PJM SRRTEP – West Reliability Analysis Update

1/4/2013

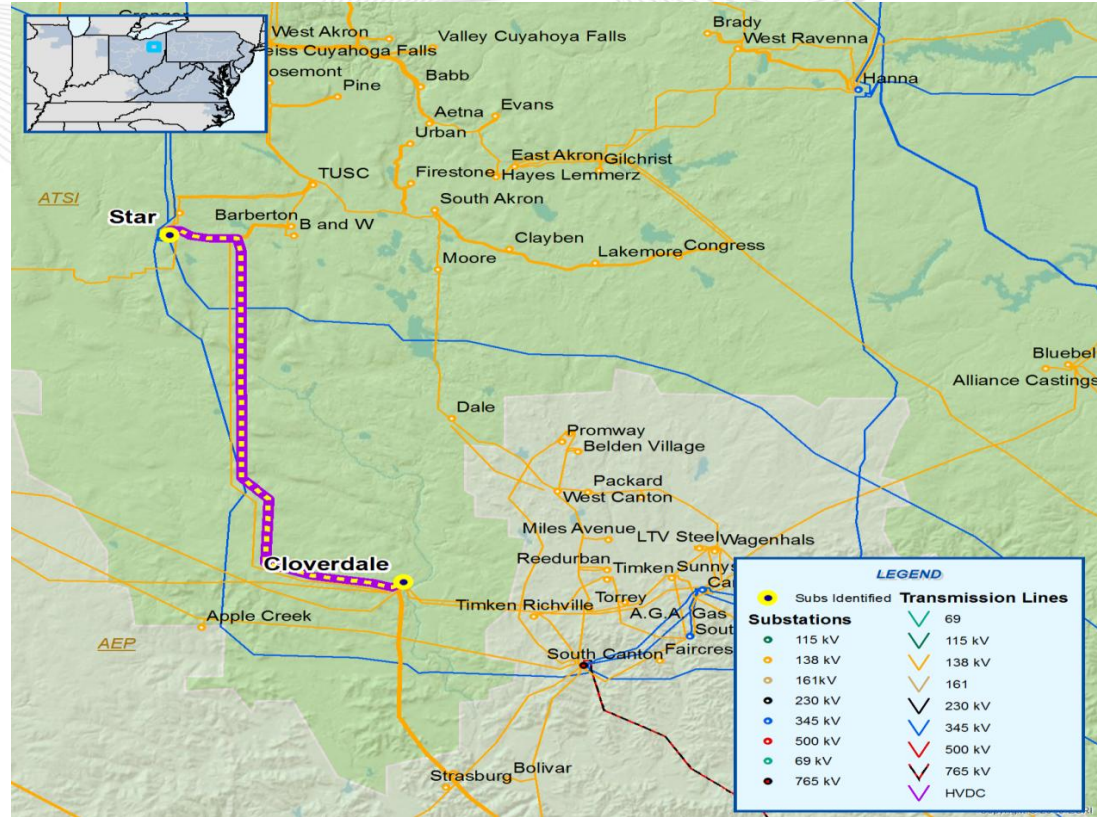
- **N-1-1 Thermal Violation**
- The Cloverdale – Star 138kV line is overloaded for the loss of the Sammis – Star 345kV line and the loss of the Harmon – Star 345kV line; The Cloverdale – Star 138kV line can not be dispatched below normal rating for the loss of the Harmon – Star 345kV line
- Increase the design operating temperature on the Cloverdale – Star 138kV line (B2105)
- Estimated Project Cost: \$0.6805M
- Projected IS Date: 6/1/2017

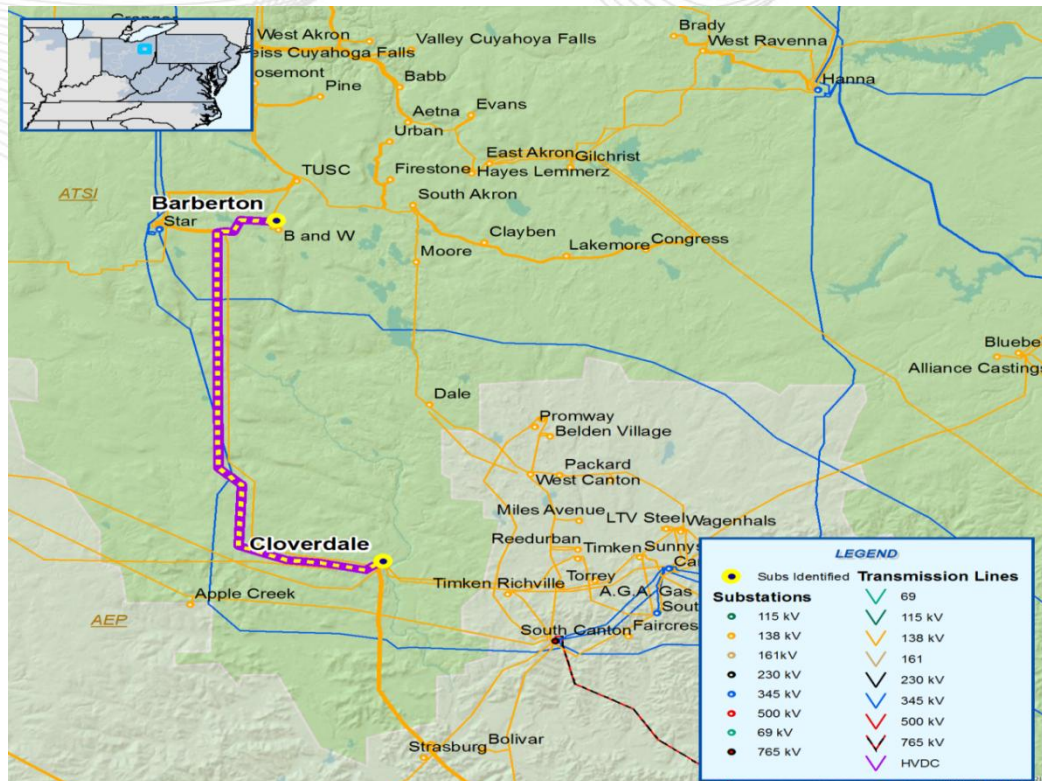
- **N-1-1 Thermal Violation**
- The Cloverdale – Barberton 138kV line is overloaded for the loss of the Sammis – Star 345kV line and the loss of the Harmon – Star 345kV line
- Increase the design operating temperature on the Cloverdale – Barberton 138kV line (B2106)
- Estimated Project Cost: \$0.6805M
- Projected IS Date: 6/1/2017

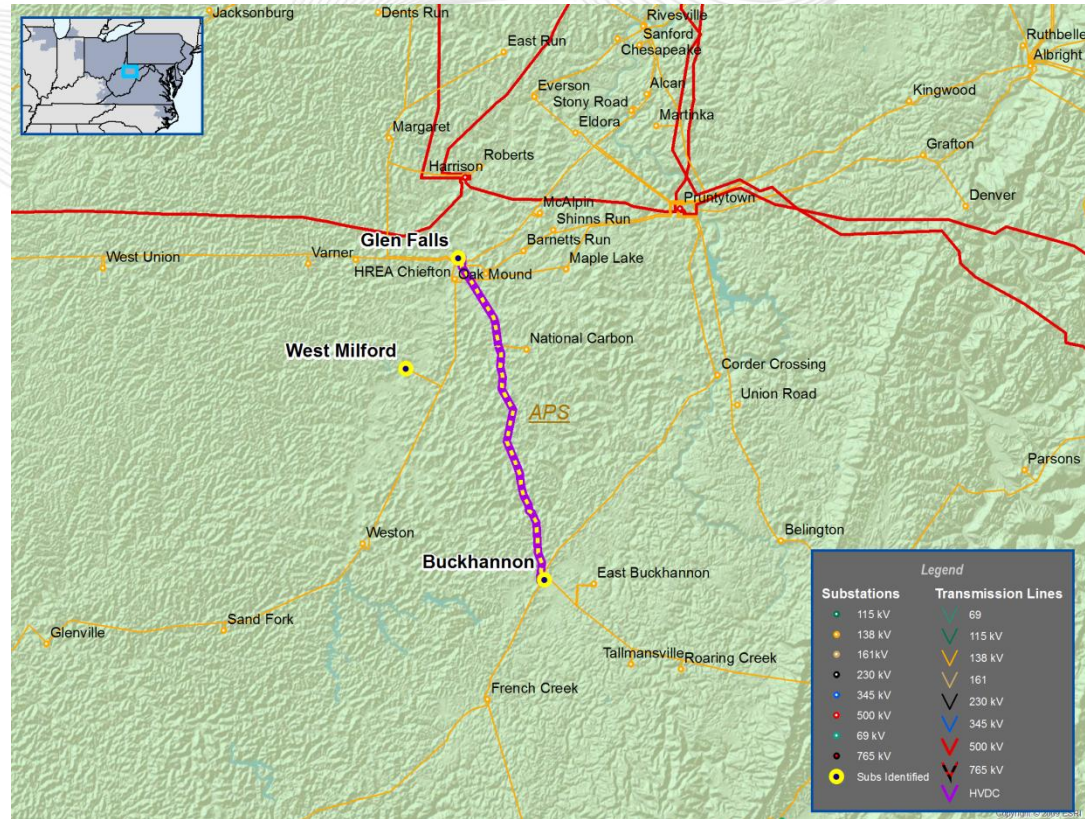
- **Project Scope Change**
- B1840
- Previous Scope: Construct a 138 kV line between Buckhannon and Weston 138 kV substations
- Previous Estimated Cost: \$17.5M
- New Scope: Loop the Buckhannon - Glen Falls 138 kV line into the West Milford 138 kV Substation
- New Estimated Cost: \$15.8M
- Projected IS Date: 6/1/2015
